100GBASE-KP4 Training Frame Update for Draft 1.2

Kent Lusted, Intel
Adee Ran, Intel

Training Pattern Update

- Applies to comments #163, 147, 149, 148
- Reviewed in 100GBASE-KP4 transmitter characteristics ad hoc on 24 October, 2012
 - Attendees:
 - Matt Brown, Charles Moore, Megha Shanbhag, Piers Dawe, Rick Rabinovich, Wheling Cheng, Adee Ran, Kent Lusted, Beth Kochuparambil, Mohammad Kermani, Vasu Parthasarathy, Rich Mellitz, Will Bliss, Zhongfang Wang, Beth Kochuparambil, Stephen Alie, Mike Dudek, Walter Katz

100GBASE-KP4 Precoding changes from D1.2

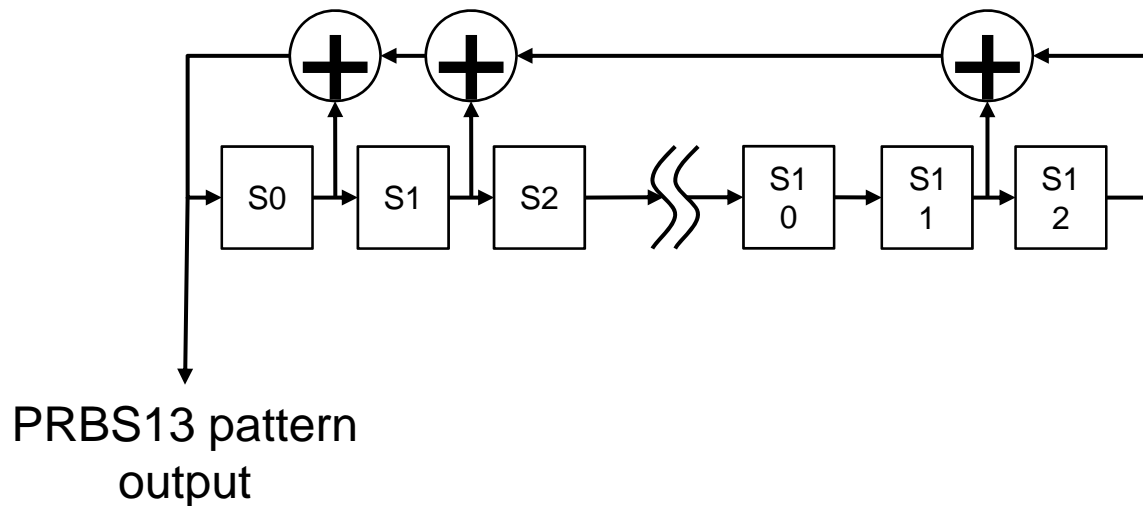
- Training frame word (TFW) is still 46 UI
 - Now TFW is same size as D1.2 termination block
 - In D1.1, 1 TFW = 2 TB46
- TFW is now created from 92 bits of PRBS13 at a time (instead of 45 bits at a time in D1.1)
 - Gray coding results in 46 bit-pairs
 - First bit-pair is used for initializing the precoder state
 - As per 94.2.2.6
 - The remaining 45 bit-pairs fed through the precoder
 - As per 94.2.2.6

Training to Data Transition

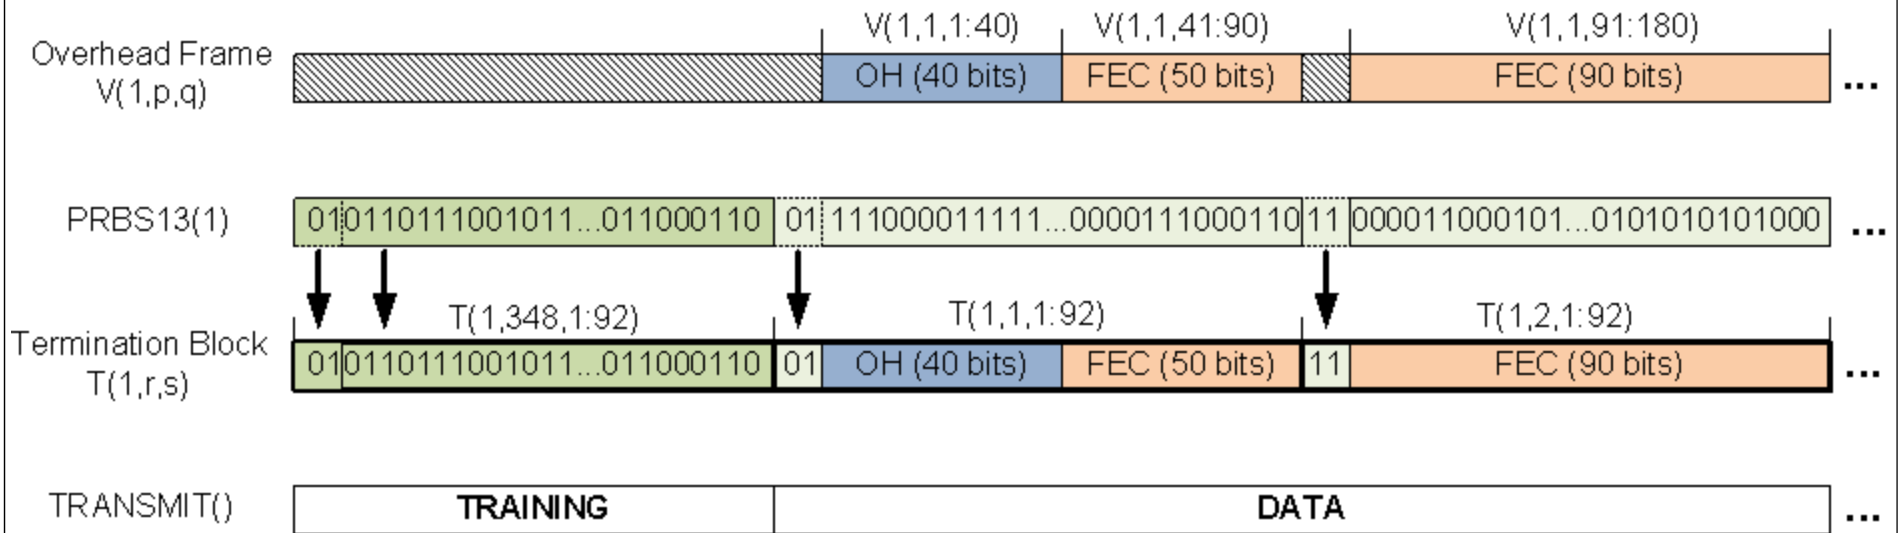
- Training frame is always aligned with the PMA frame; last training frame is immediately followed by 40-bit overhead of data
 - No need for PAO field in training (only in EEE alert)
 - Countdown field still used to signal transition
 - 40-bit overhead must start with a termination symbol to be consistent
 - Bit-inversion of PRBS13 is removed (present in 2nd and 4th PRBS cycle)
- PRBS13 is re-seeded at the beginning of each training sequence during training mode, but keeps running freely in data mode
 - Termination bits get synced during training
 - PRBS always advances 92 bits per TFW in training and by 92 bits per term block in data mode
 - Do not reseed first PMA frame after training ends
 - Do not reseed in data mode at start of each PMA frame

- Notes:
 - PRBS13 bit inversion ends with transition to data mode

ALERT Frame

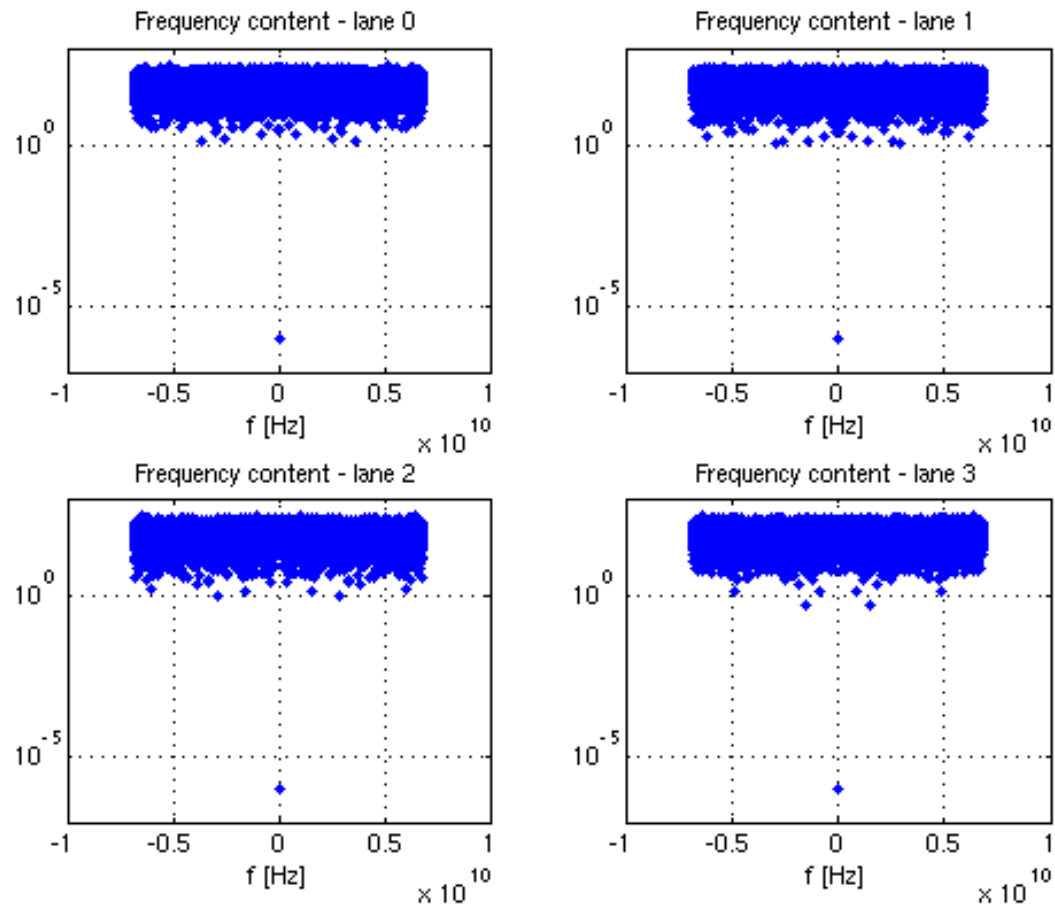
- Update ALERT frame as outlined in this document:
 - Keep the short frame length of 58 TFW in Draft 1.2
 - 1 TFW = 1 TB92
 - Use the aforementioned PRBS13 generator, polynomial, seeds, etc.
